SUBJECT: COMANCHE PEAK NUCLEAR POWER PLANT, UNITS 3 AND 4
DOCKET NUMBERS 52-034 AND 52-035
RESPONSE TO REQUEST FOR ADDITIONAL INFORMATION NO. 5092
(SECTION 3.8.4)

RESPONSE TO REQUEST FOR ADDITIONAL INFORMATION

RAI NO.: 5092 (CP RAI #185)

SRP SECTION: 03.08.04 - Other Seismic Category I Structures

Figure 1

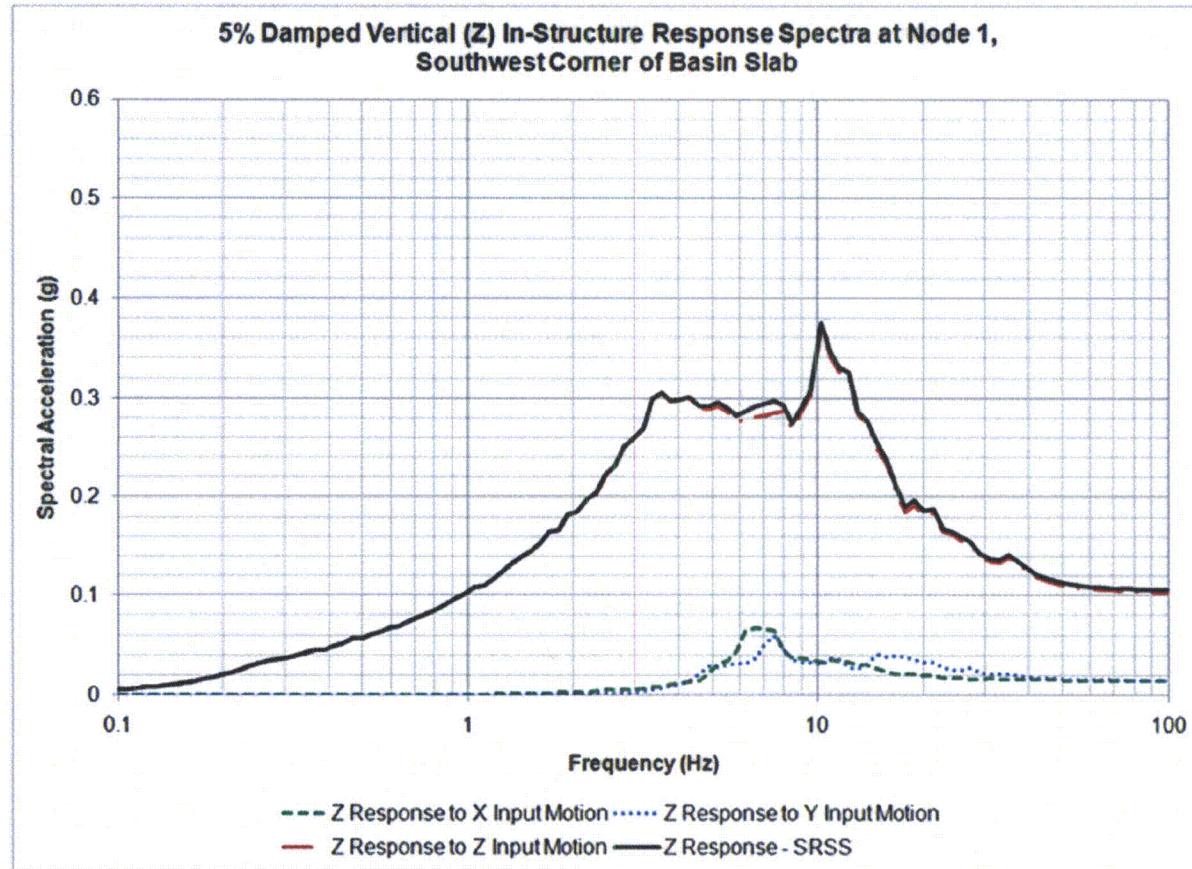
In its response to RAI 4542 Question 03.08.04-70 (dated August 9, 2010), Luminant addresses the two parts of the question, Part (a) and Part (b). The answer provided by the Applicant to Part (b) of Question 03.08.04-70 is acceptable. However, the answer to Part (a) is not acceptable. Unlike the structural mass which is independent of the base motion it experiences, the impulsive liquid mass depends on the base motion. More specifically, the distribution of impulsive mass along the height of the tank wall under the horizontal excitation is different from that under the rocking excitation. In the response, the applicant states that NUREG-0800, Standard Review Plan (SRP) 3.7.3 Acceptance Criteria 14 was followed in the analysis, and the analyses use a full three-dimensional model where the vertically acting mass of water is uniformly distributed to the base slab and the horizontally acting impulsive mass of the water is uniformly distributed along the wall height, such that the center of gravity of the impulsive mass is at a height of one-half the water depth. The staff disagrees with the applicant's position. In SRP 3.7.3 Acceptance Criteria 14, the analysis approach that the applicant used is not mentioned. SRP 3.7.3 Acceptance Criteria states that, "Most above-ground fluid-containing vertical tanks do not warrant sophisticated, finite element, fluid-structure interaction analyses for seismic loading." The center of gravity of the impulsive mass depends on the value of liquid height to tank radius ratio. It is not necessary to be at one-half the water depth. Also, the center of gravity of the impulsive mass for the horizontal base excitation is different from that of the rocking base excitation.

The Applicant is requested to provide information that explains how the fluid masses corresponding to the base rocking motion are calculated and included in the model, taking into account the staff's comments cited above.

The SSI analyses use a full three-dimensional structural model supported by the free field soil without nodal constraints and is therefore capable of modeling rocking motion. The extent of SSI-induced rocking for the UHSRS is examined through a comparison of the vertical best-estimate soil 5% damped in-structure response spectra components at node 1, located at the southwest corner of the basin slab, and node 2166, located at the northwest corner of the basin slab. These comparisons are shown in Figure 1 and Figure 2, respectively. Since these locations are at edge corners stiffened by the outer walls, any rocking of the structure due to horizontal input motion is observed as vertical motion of the corner node.

As shown in the figures below, there is very little rocking present in the structure, on the order of 0.02 g peak ground acceleration and nearly zero in the low frequency regions that would excite convective modes. The lack of significant rocking is consistent with the stiff subgrade of this foundation supported on limestone.

Since the UHSRS is not experiencing significant motions representative of base rocking, additional consideration of modeling to capture the effect of base rocking on hydrodynamic pressures is unnecessary.
